Application No. Applicant(s) 10/642,810 EKKERT, LEN Notice of Allowability Examiner Art Unit Niki M. Eloshway 3781 -- The MAILING DATE of this communication appears on the cover sheet with the correspondence address--All claims being allowable, PROSECUTION ON THE MERITS IS (OR REMAINS) CLOSED in this application. If not included herewith (or previously mailed), a Notice of Allowance (PTOL-85) or other appropriate communication will be mailed in due course. THIS NOTICE OF ALLOWABILITY IS NOT A GRANT OF PATENT RIGHTS. This application is subject to withdrawal from issue at the initiative of the Office or upon petition by the applicant. See 37 CFR 1.313 and MPEP 1308. 1. A This communication is responsive to the after final amendment filed 10/10/06. 2. The allowed claim(s) is/are 1-7 and 9-11. 3. Acknowledgment is made of a claim for foreign priority under 35 U.S.C. § 119(a)-(d) or (f). a) \square All b) Some* c) None 1. Certified copies of the priority documents have been received. 2. Certified copies of the priority documents have been received in Application No. 3. Copies of the certified copies of the priority documents have been received in this national stage application from th

FIG. 1

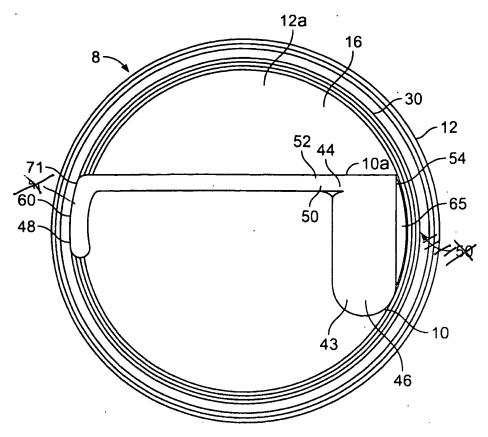
- 2. The drawings were received on October 10, 2006. These drawings are not accepted because the replacement sheets have not been labeled "Replacement Sheet" as required by 37 CFR 1.121 (d).
- 3. The following changes to the drawings have been approved by the examiner:
 - (a) In figure 1, the reference number 41 on the left side of figure 1 must be deleted.
- (b) Reference number 61 should be added to figure 1A to designate the portion of the material section,
 - (c) In figure 1, the reference number 50 on the far right side of the figure must be deleted,

FIG. 1A

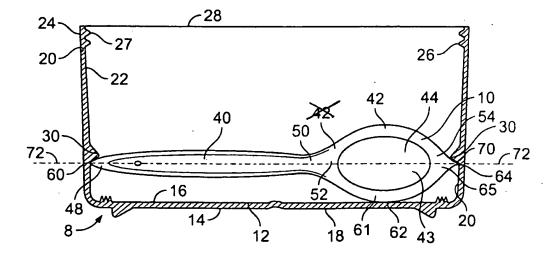
(d) In figure 1A, reference number 42 located between reference numbers 50 and 42 must be deleted,

FIG. 3

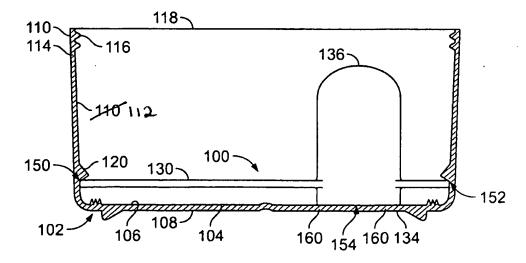
- (e) In figure 3, reference number 110 located directly below reference number 116 must be changed to --112--, and
- (f) In figure 5, the lead line for reference number 324 should be directed to the open top of the material section 322.
- **Attached is a marked-up copy of the drawings showing the addition or alteration to be made.**
